11 December 2019

RE: SANCROX QUARRY EXPANSION PROJECT – PROJECT NUMBER – SSD-7293

Attachmnet 1b

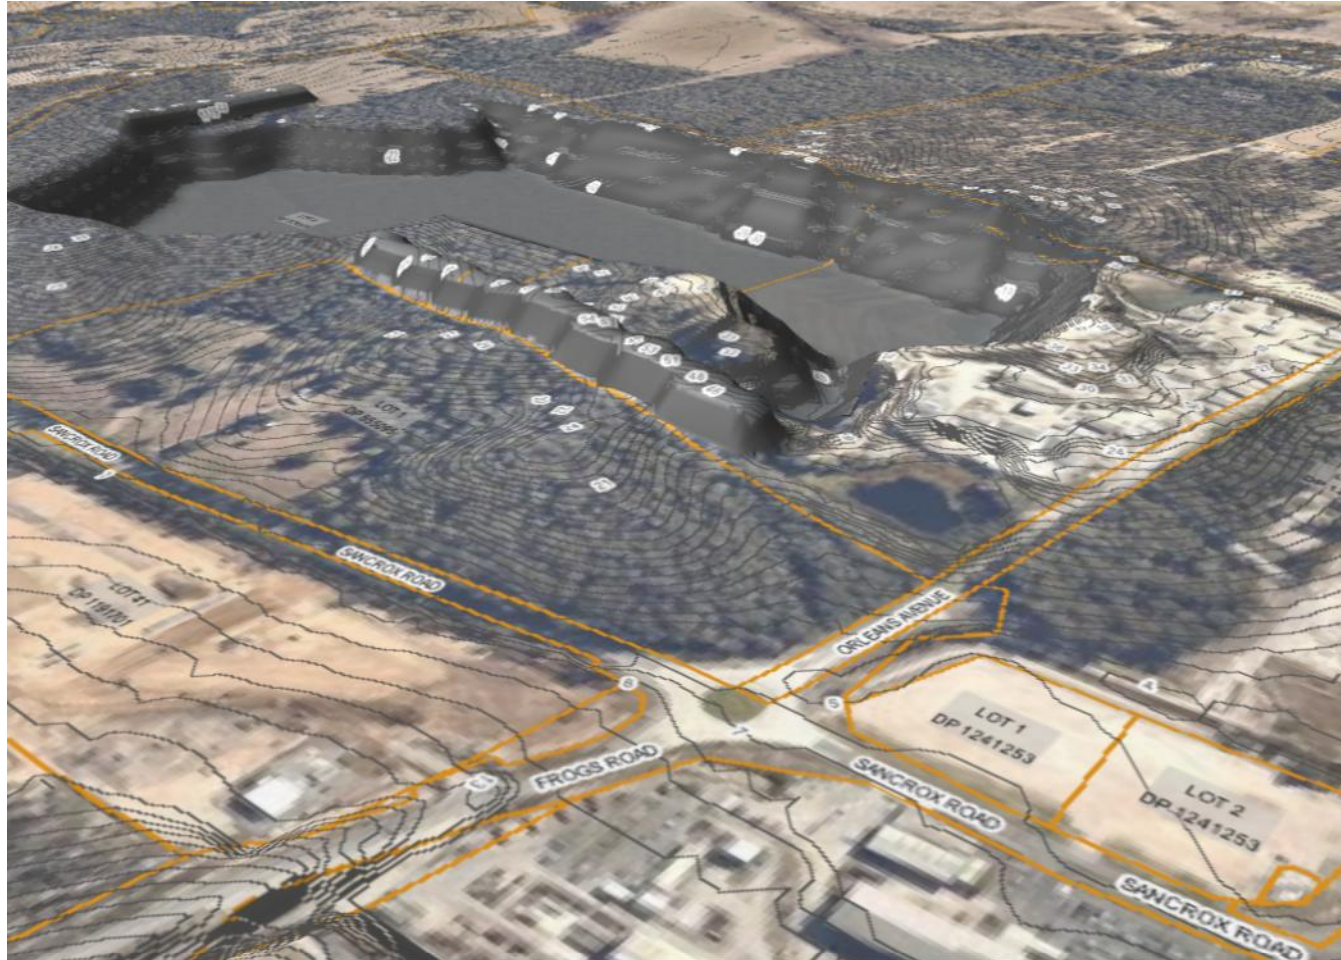
- We have been provided with a digital model of the completed quarry as proposed, that has been developed using the current topography and the proposed quarry excavation contours. It is noted that no such model has been included in the EIS for the proposed expansion which is a fundamental omission in the documentation. The proposed quarry void is estimated to generate 52 million tonnes of material, which, even allowing for 15% for overburden, over the proposed 30 years, will generate 1,473,333 tonnes of quarry material per annum. (Refer **Attachments 1a & 1b**)

This is nearly double the proposed 750,000 tonnes per annum sought in the current application, or alternatively, at 750,000 tonnes per annum, the proposed quarry extent will provide a life almost double that requested.

Figure 10 Notional linkages for the Greater Sancrox planning area

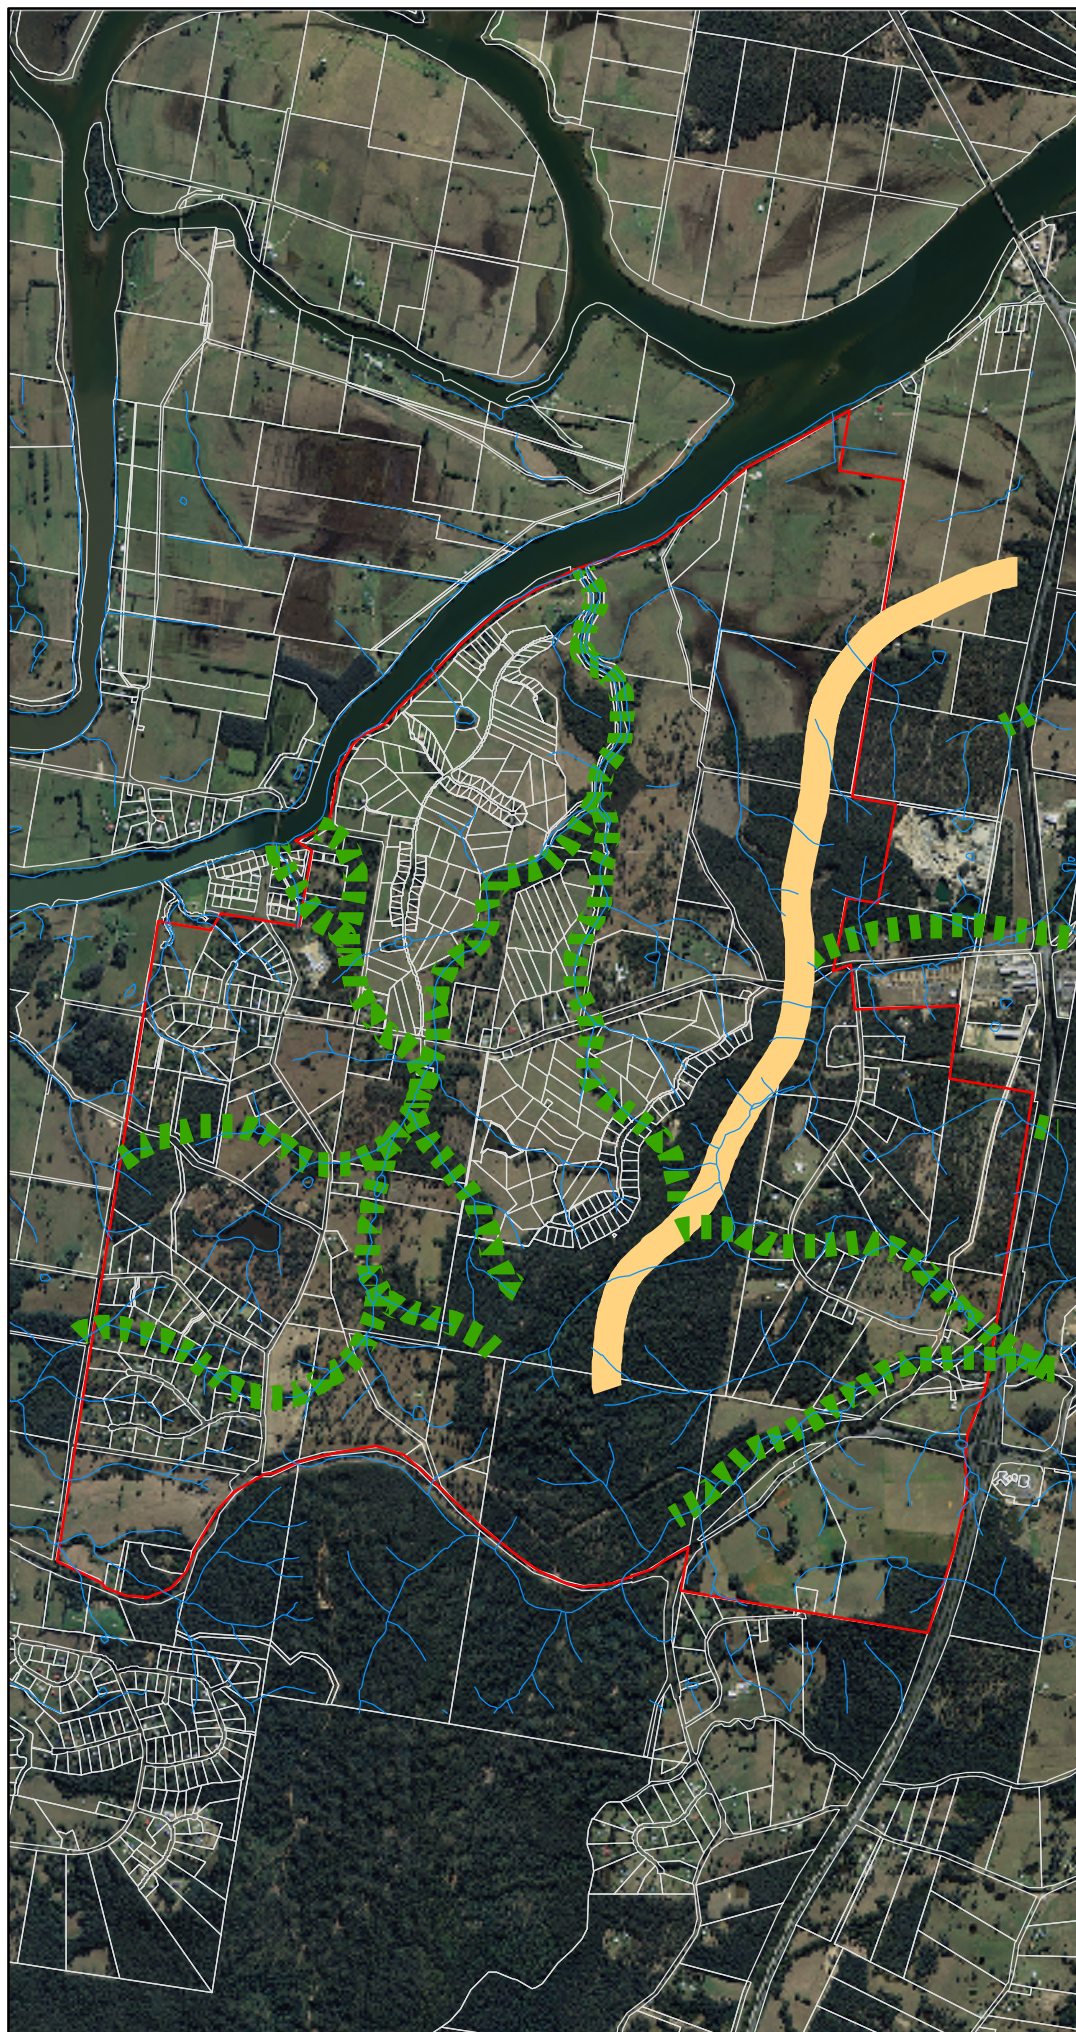
- The EIS and associated biodiversity report makes limited references to previous ecological assessments completed as part of various urban growth and development proposals in the immediate area and including this site.
- The report assessments outcomes differ significantly from those carried out previously. The 2011 Biolink report prepared for Port Macquarie-Hastings Council (PMHC) as part of the Greater Sancrox Structure Plan, identified the majority of the area proposed for the quarry expansion as being part of a Sub-regional Corridor (Fig 10). (Refer **Attachment 2**)

The Connectivity Links provided with the EIS (Appendix E), have not been placed over aerial photographs to allow the proposal to be assessed, in the context of the overall area.

Table 5.7 in the EIS proposes mitigation measures including “Design and implement a planting plan for corridor of native vegetation east and west of proposed quarry pit, to maintain north-south corridor link of trees, as per sub-regional corridor in the Biolink Greater Sancro Structure Plan (PMHC 2015)”.

Given the quarry’s current development and removal of all vegetation up to its eastern boundary, together with the proposal to place a bitumen plant in this area, there is no indication in the EIS how a future eastern vegetated link can be established within the quarry property boundaries.

Figure 3 Hollow-bearing trees and Significant Vegetation Communities

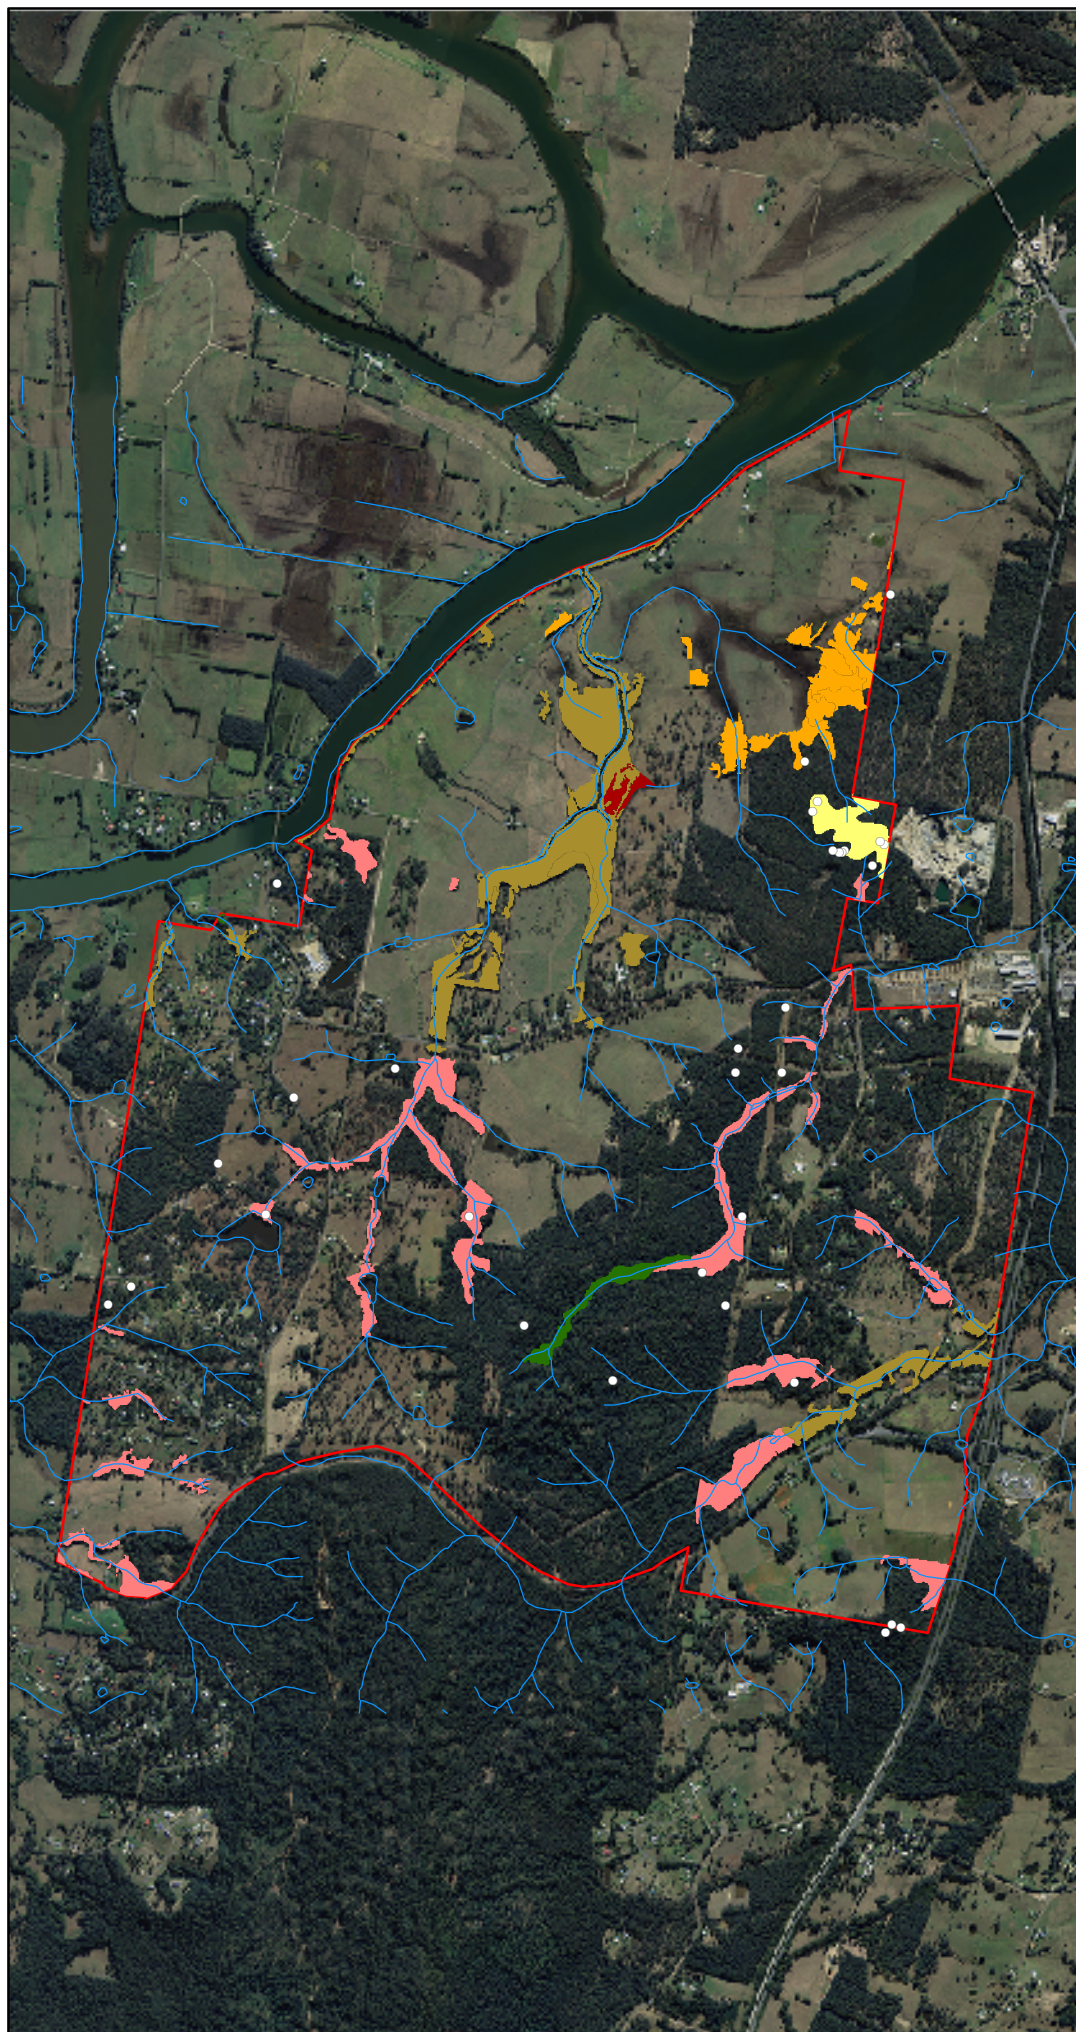
- The ecological report within the EIS has not identified any of the Hollow Bearing Trees within the quarry footprint previously identified in the Biolink report. (Refer **Attachment 3**)
- The quarry excavation contours and infrastructure areas proposed, do not relate to the surrounding topography and therefore it is not possible to determine the actual extent of clearing proposed.

Figure 9 Ecological values

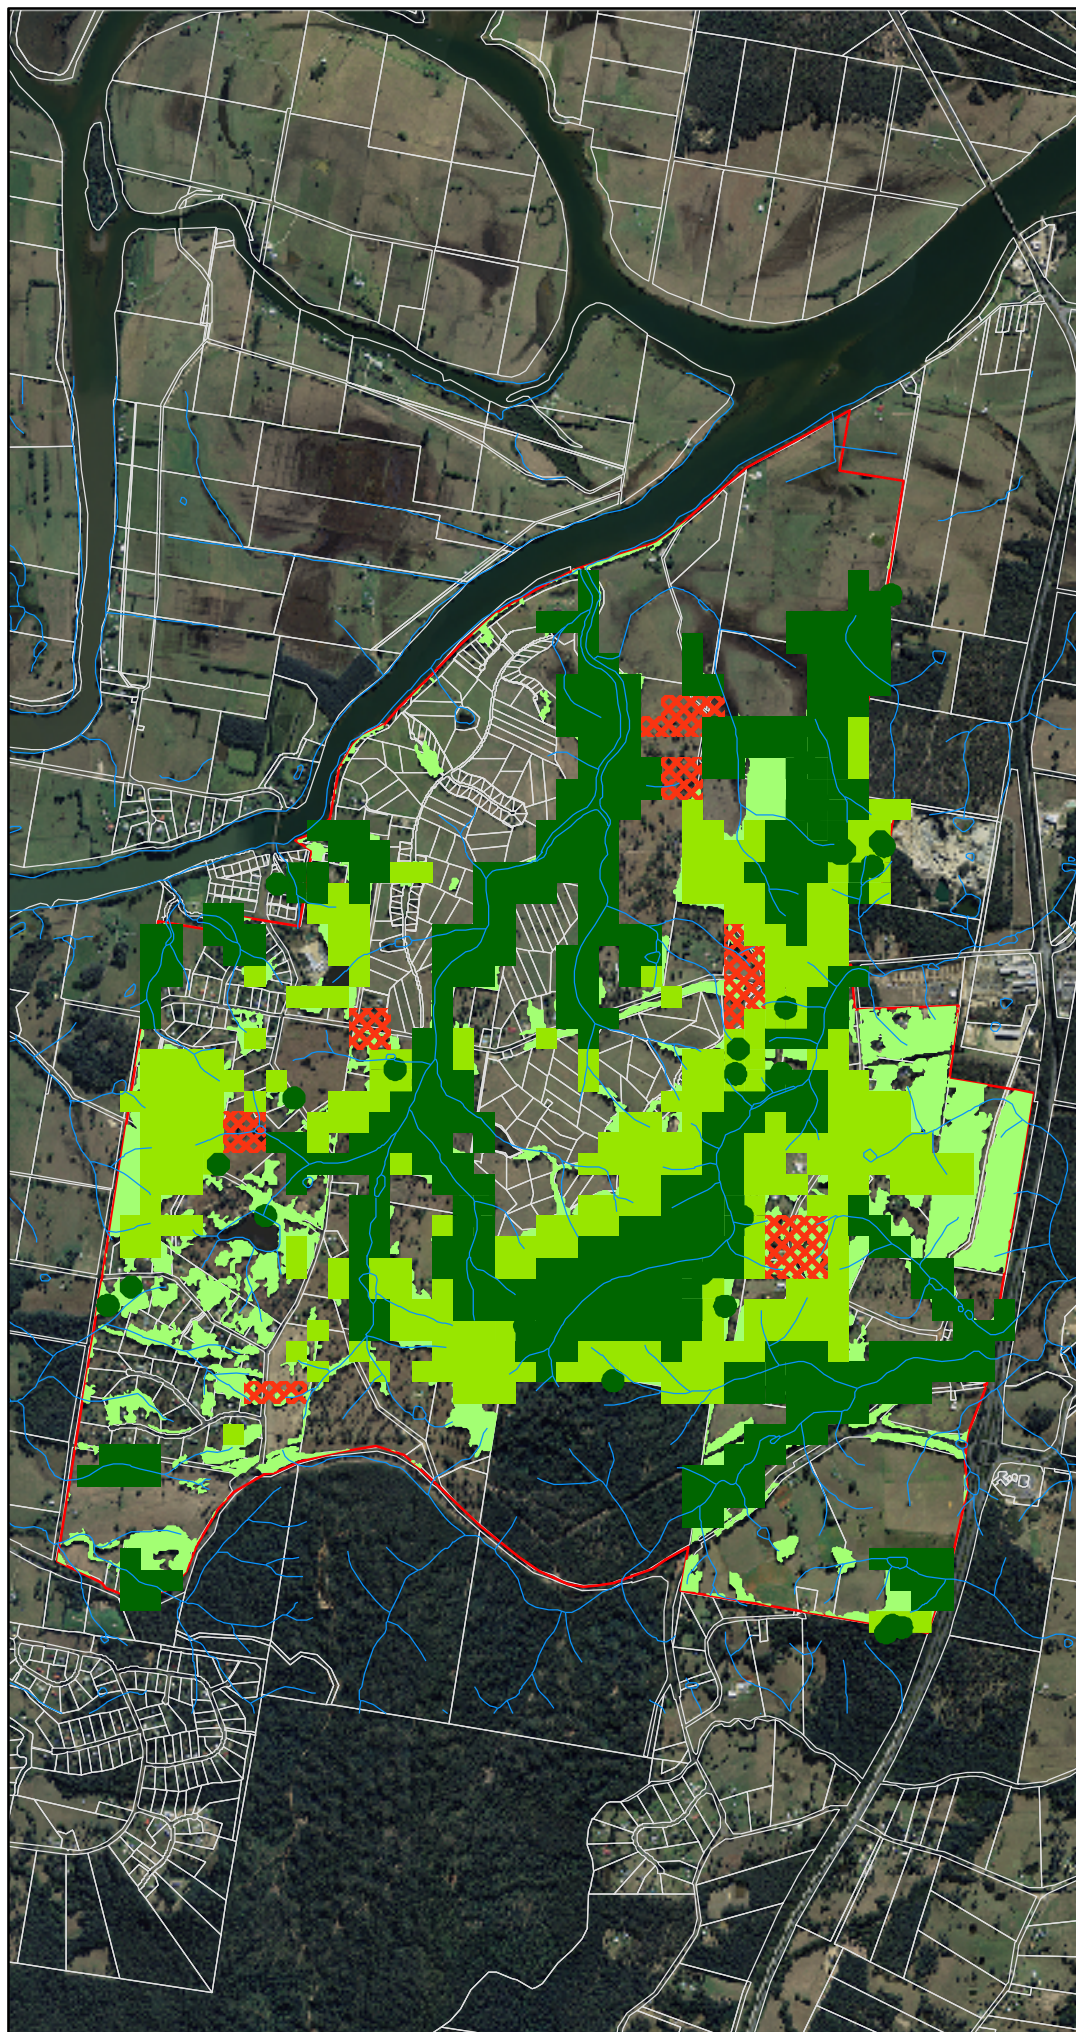
In terms of ecological values, the area proposed for quarry expansion was mapped as either “irreplaceable” or be “value managed”.

The Biolink Report identified much of the vegetation proposed to be removed by this development or potentially affected by the changes in surface and ground water regimes as “irreplaceable or needing “value management”,(Refer **Attachment 4**).

Figure 7 Location of SAT sites, koala sightings and
distribution of core koala habitat

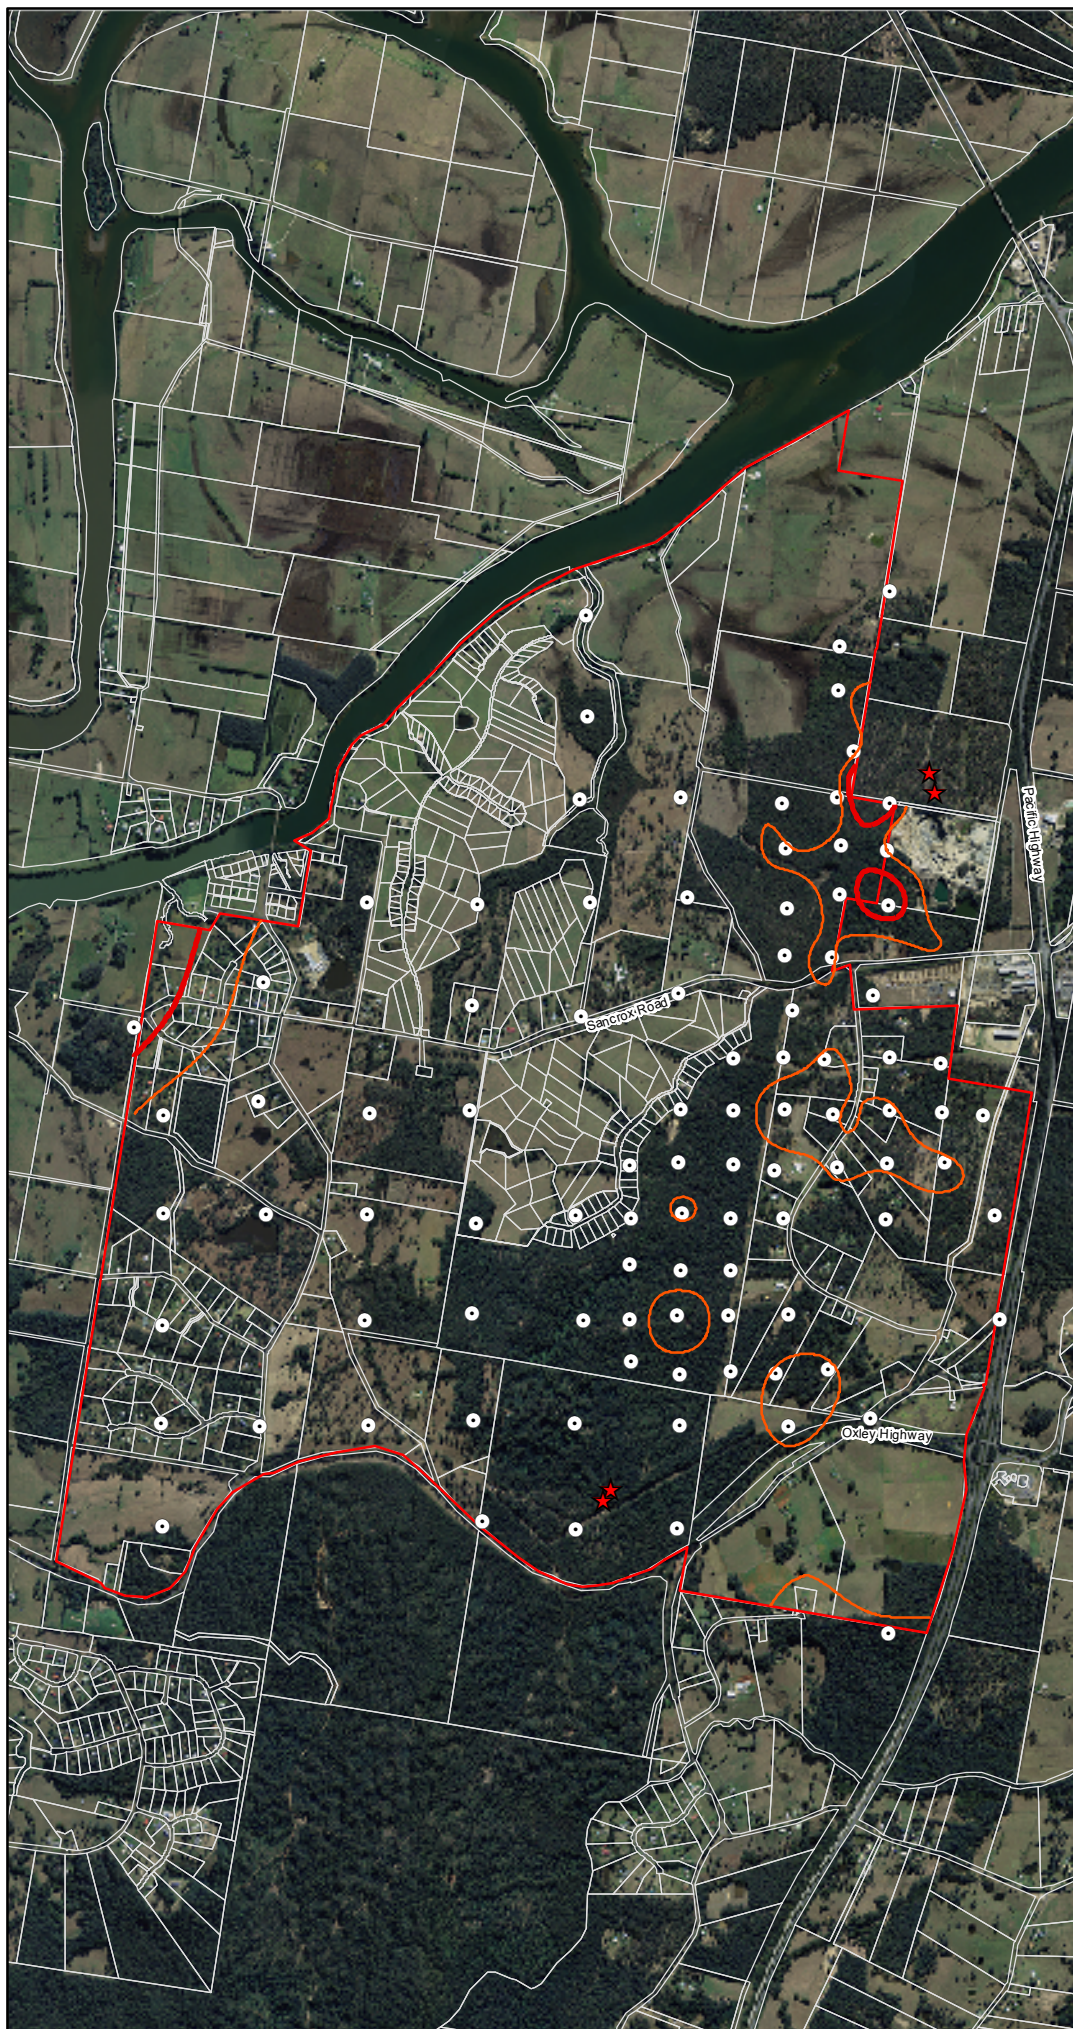
The Biolink Report identified much of the area proposed to be cleared as Core Koala Habitat, either high or medium use. (Refer **Attachment 5**)

The ecological report with the EIS acknowledges that the site is “potential koala habitat” in accordance with SEPP 44 and that 805 records exist of koala in the search area but does not reference the approved KPoMs adjoining the southern and northern boundaries of the proposed quarry expansion. This omission is a further fundamental flaw in the ecological assessment contained in the EIS.
